**FINAL
DIRECT-PUSH
WORK PLAN FOR SITE 9 ASH DELINEATION AND
INVESTIGATIONS AT BUILDING 201 AREA OF CONCERN
AND IRRIGATED PLAYING FIELDS, NAVAL AIR STATION
BRUNSWICK, MAINE**

**RESPONSE TO COMMENTS FROM THE
UNITED STATES ENVIRONMENTAL PROTECTION AGENCY
DRAFT WORK PLAN FOR SITE 9, BUILDING 201 AOC, & IRRIGATED
PLAYING FIELDS
NAVAL AIR STATION BRUNSWICK, BRUNSWICK, MAINE**

**RESPONSE TO COMMENTS FROM THE
BRUNSWICK AREA CITIZENS FOR A SAFE ENVIRONMENT (BACSE)
DRAFT WORK PLAN FOR SITE 9, BUILDING 201 AOC, & IRRIGATED
PLAYING FIELDS
NAVAL AIR STATION BRUNSWICK, BRUNSWICK, MAINE**

**RESPONSE TO COMMENTS FROM THE
MAINE DEPARTMENT OF ENVIRONMENTAL PROTECTION
DRAFT WORK PLAN FOR SITE 9, BUILDING 201 AOC, & IRRIGATED
PLAYING FIELDS
NAVAL AIR STATION BRUNSWICK, BRUNSWICK, MAINE**

Figure 4

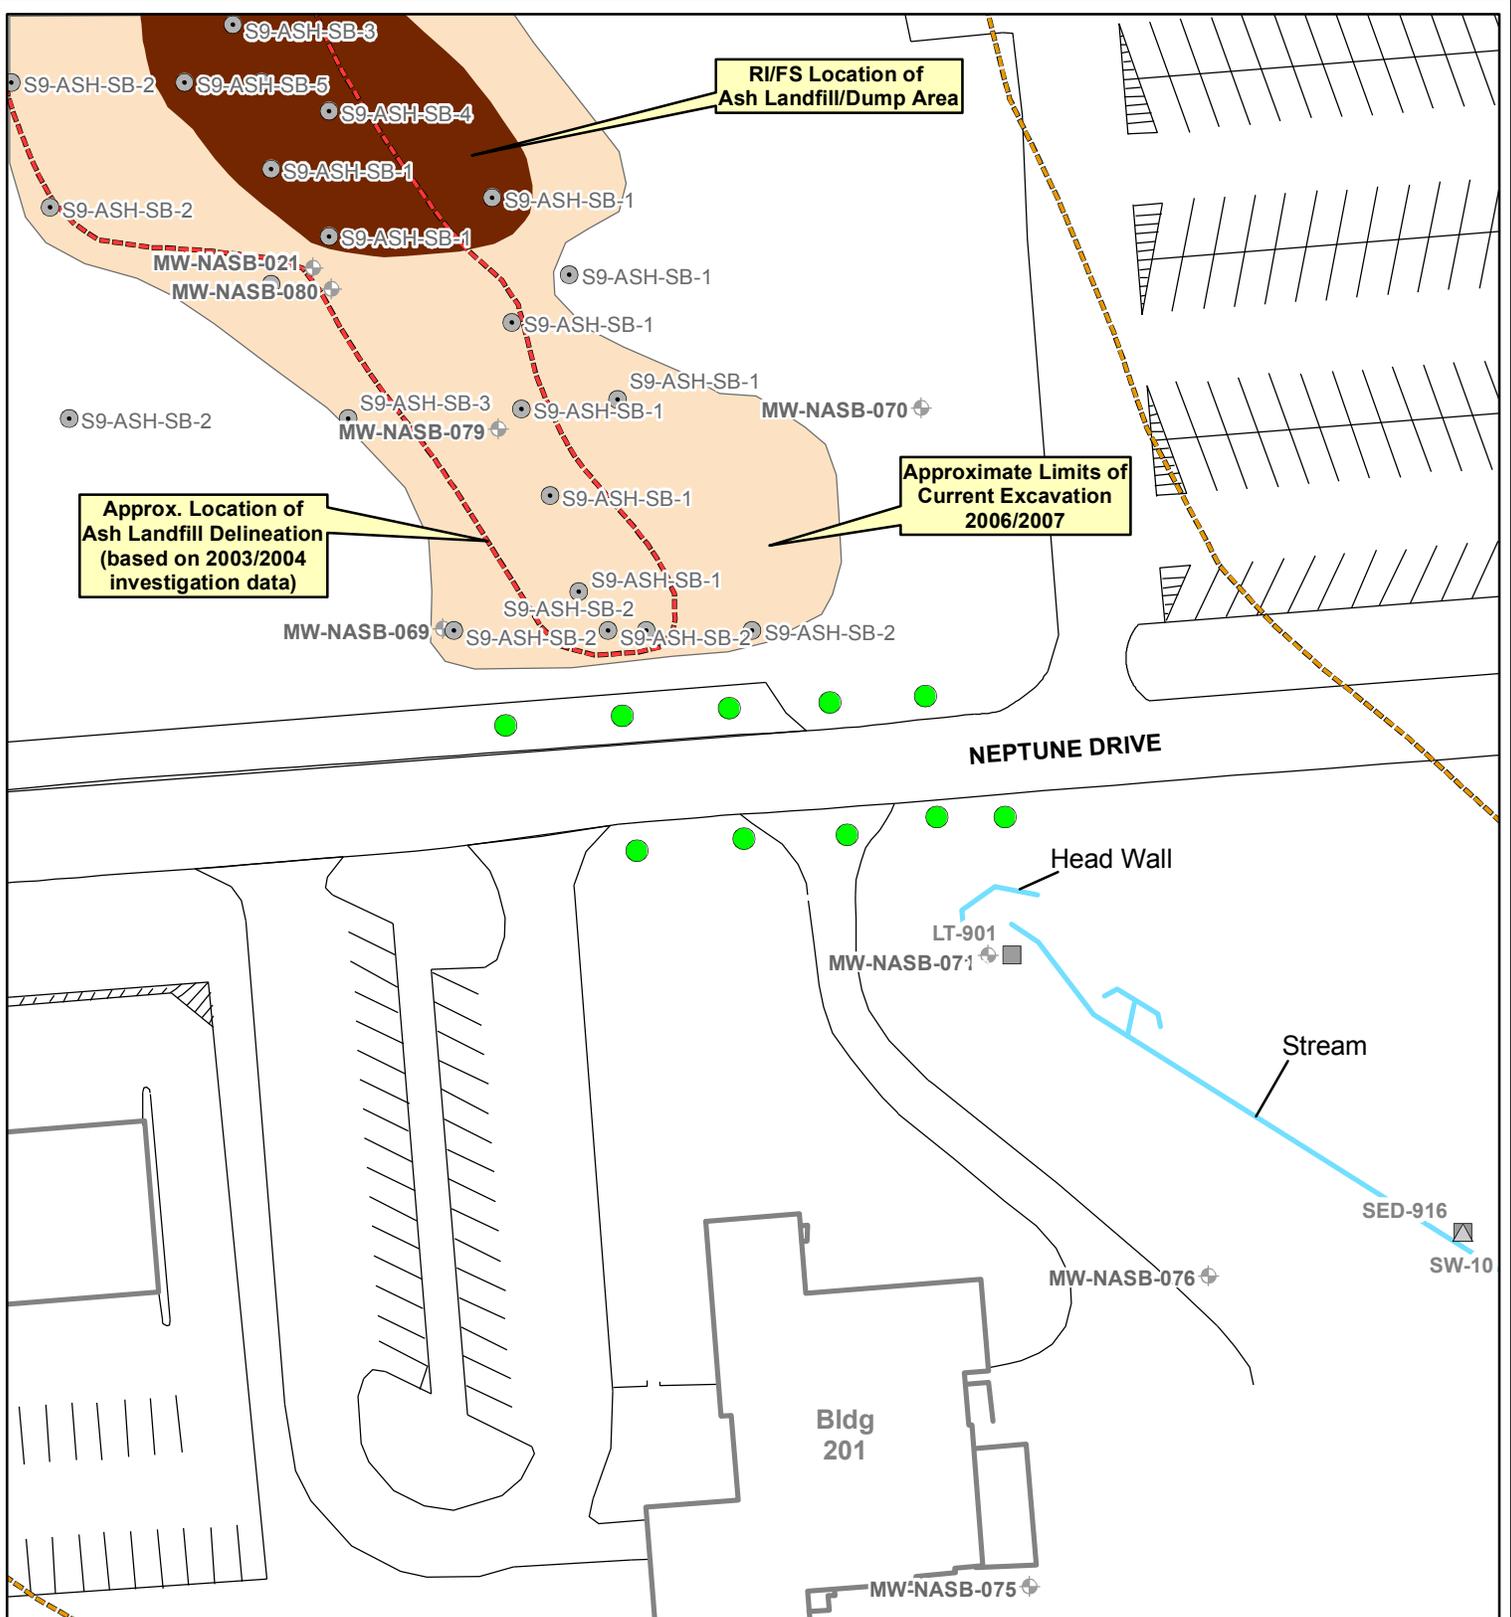
3. **p. 2, sec. 2.1:** The Work Plan indicates that 10 DP borings will be advanced in the neighborhood of Neptune Drive to attempt to delineate the extent of the ash layer that was still present when excavation was halted at its southern extreme. Up to 20 additional DP borings are allocated in the event that the ash is detected, but not bounded, by the initial 10 holes. It is noted that Figure 4 shows 15 boring locations. It is not clear if this is only intended to be “schematic” (i.e., showing only the general concept) or “exact.” If the latter, it is not clear which ten of the locations shown are intended as initial targets. Also, please elaborate on the process envisioned for continuing with (and locating) additional borings after the initial ten. Is the intent to continue with up to 30 borings in a single mobilization, or will there be an interim step of reporting results from the initial 10 borings? Will regulators have an opportunity to discuss the locations of the additional borings, if such are indicated?

6. **Figure 4:** please include the outline of the current excavation.

4. Figure 4. The trace of the former stream channel (MEDEP comment number 7) and the former 40-inch drainpipe shown on Figure 5-1 of the 1996 Draft *Site 9 Source Investigation Report* should be added to Figure 4.

13. Figure 4:

a.) It would be more helpful if the current pit boundary was shown of the figure rather than the 2003/2004 delineation which we now know was in error. Please revise.

b.) Also add the unnamed stream/drainage. The location of the stream may effect the location of the proposed soil borings.

c.) Since the figure depicts 15 proposed direct push locations please indicate which are the initial 10 borings and which are the follow-up points.

- Per our discussion, Figure 4 (emailed 5/15/07) is revised again to include the approximate location of the existing excavation and the unnamed stream south of Neptune Drive. If feasible, the western most direct push point south of Neptune Drive will be relocated to the extreme east to determine if the ash landfill was located in the old stream channel;

Response: Figure 4 will be revised to show 5 boring locations on the north side of Neptune Drive (as currently shown between the current excavation and Neptune Drive), and 5 locations on the south side of Neptune Drive, opposite the borings on the north side of Neptune Drive. These locations may be adjusted in the field based on results from the first few borings. If results from the initial 10 borings indicate the presence of ash, it is intended to continue with the investigation without having to re-mob. The regulators will be advised of the results from the initial borings, and will be given the opportunity to comment promptly on the additional borings.

Response: Agreed. Figure 4 will be revised in accordance with this comment and included in the Final Report.

Response: Figure 4 will be revised to show the approximate location of the former 40-inch drainpipe as shown in Figure 3-1 from the Source Investigation Sampling and Analysis Plan (ABB, January 1995). The former stream channel will also be shown provided ECC can obtain a copy of the 1940's aerial photograph referenced in MEDEPs comment No. 7. This revised Figure will be included in the Final Report.

Response: Agreed. Figure 4 will be revised to reflect the current excavation as close as possible. The revised Figure will be included in the Final Report.

Response: Agreed. Figure 4 will be revised to include the location of the unnamed stream/drainage area. The revised Figure will be included in the Final Report.

Response: Figure 4 will be revised to show 5 boring locations on the north side of Neptune Drive (as currently shown between the current excavation and Neptune Drive), and 5 locations on the south side of Neptune Drive, opposite the borings on the north side of Neptune Drive. These are the initial 10 borings. These locations may be adjusted in the field based on results from the first few borings. The regulators will be advised of the results from the initial borings, and will be given the opportunity to promptly comment on the additional borings locations. The revised Figure will be included in the Final Report.

Figure 5

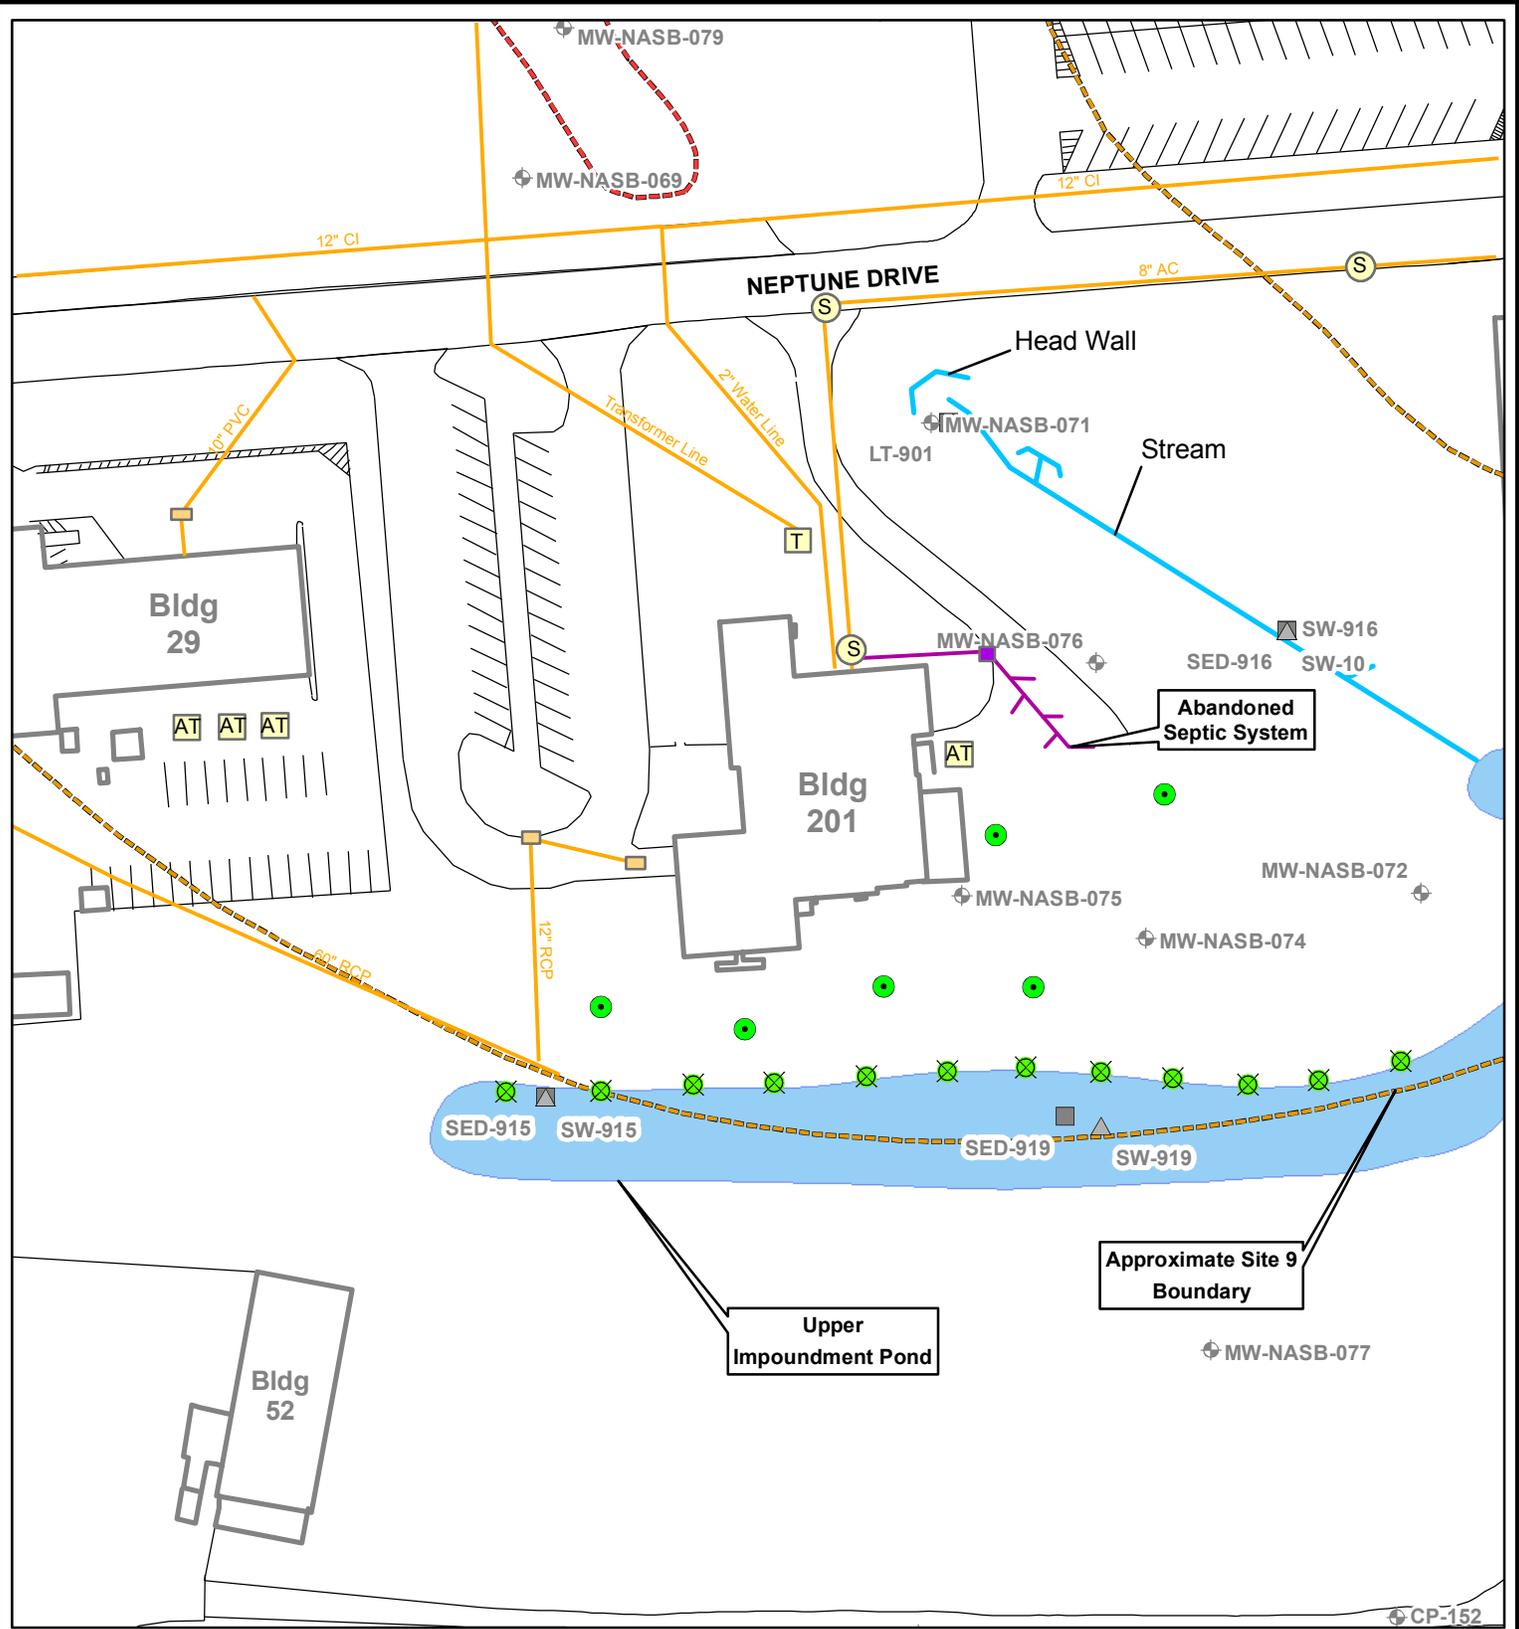
8. **p. 5, sec. 3.2 and Fig. 5:** Please provide the rationale for the proposed boring locations. It would appear that the working hypothesis is that the fuel compounds detected in groundwater and in the pond may have been released somewhere in close proximity to

11. **Figure 5:** add the storm and sanitary utility lines associated with building 201 and the hobby shop. Also add the location of the restaurant grease trap and storage area and previous location of the hobby shop waste oil tank.

17. Sections 3.4 and 3.5: Based on the site visit by stakeholders on April 4th 2007, MEDEP understands that the soil boring and associated groundwater sample locations will be revised from those shown on Figure 5. MEDEP suggests that the two western locations and the location north of MW-NASB-075 are appropriate, but agrees that one of the remaining locations should be relocated north and east of MW-NASB-074 and MW-NASB-075.

- Per our discussion, Figure 5 (emailed 5/15/07) is revised again to extend the pore water sample locations approximately 100 feet by evenly redistributing the sample locations;

Response: According to sampling data from January 2006, MW-NASB-74 and MW-NASB-76 were non-detect for DRO. Based on the historical detections of DRO in MW-NASB-75, and the presence of a sheen and stressed vegetation along the Upper Impoundment Pond northern bank, the rationale for the sampling locations is to identify a potential contaminant source south and to the west of Building 201.

Response: Agreed. Figure 5 will be revised to the extent that the information requested is available. The revised figure will be include in the Final Report.

Response: Agreed. Figure 5 will be revised and include in the Final Report.

Response: The porewater points will be evenly redistributed to cover this area. Figure 5 will be revised in accordance with this comment.

Figure 6

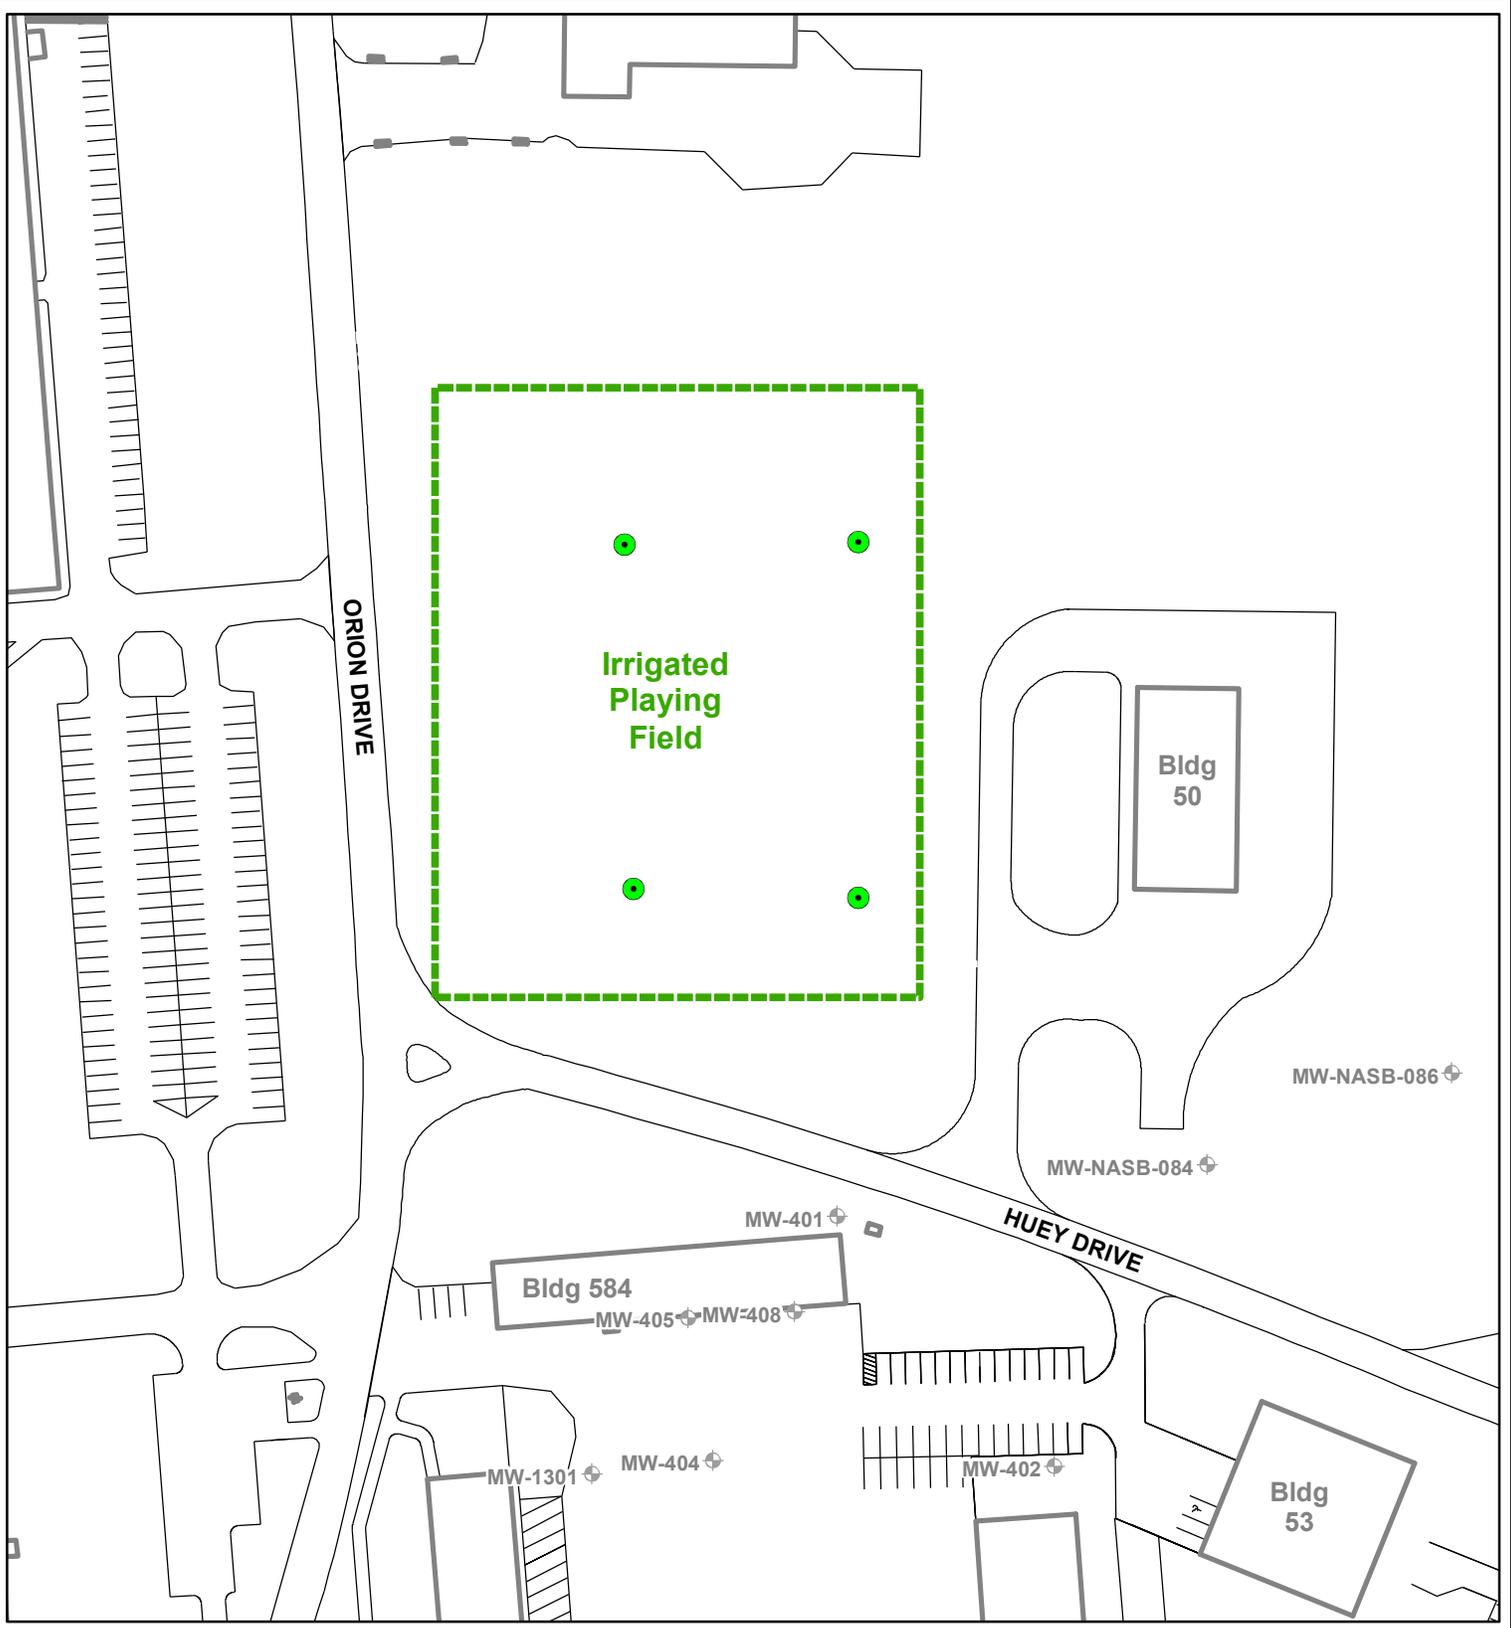
15. **p. 9, sec. 4.3 and Fig. 6:** The Work Plan proposes four water-table samples to be collected from within the footprint of the playing field. What is the anticipated groundwater flow direction at this site, and how do the proposed DP locations relate to the flow? Based on the general location of the field, it seems likely that the flow is from NW to SE. If this is the case, the proposed DP locations near the NE, NW, and SW corners of the field have very little of the irrigated area lying upgradient. Only the SE corner is downgradient of a significant portion of the field. If it is believed that the flow is from NW to SE, it is recommended that the NE location be moved south (e.g., to the midpoint of the E side of the field), and the SW location be moved east (e.g., to the midpoint of the S side of the field), so that more of the irrigated area lies upgradient of these points. The NW point (as shown) will provide a comparison to groundwater that has received little recharge from the irrigation system.

- Per our discussion, Figure 6 is revised by moving the two most westerly sampling points directly east approximately 50 feet, however ECC personnel and Chris Evans will reevaluate these locations in the field once the information on the irrigation is supplied and taking into consideration EPA's recommendations;

Response: The Navy will take this comment into consideration when implementing the field program at the Irrigated Playing Field. One of the main considerations which should be taken into account when choosing the sampling locations is the location of the sprinkler heads which discharge the effluent water from the GWETS to the playing field surface. In the Navy's response to MEDEP Comment No. 20 a, the Navy agreed to contact the NASB Public Works Department to ascertain the location of the sprinkler heads prior to marking the direct push locations. These locations can be adjusted in the field when taking into account the location of the sprinkler heads and the interpreted groundwater flow direction at the playing field.

Response: Agreed. Figure 6 will be revised in accordance with this comment and included in the Final Report.
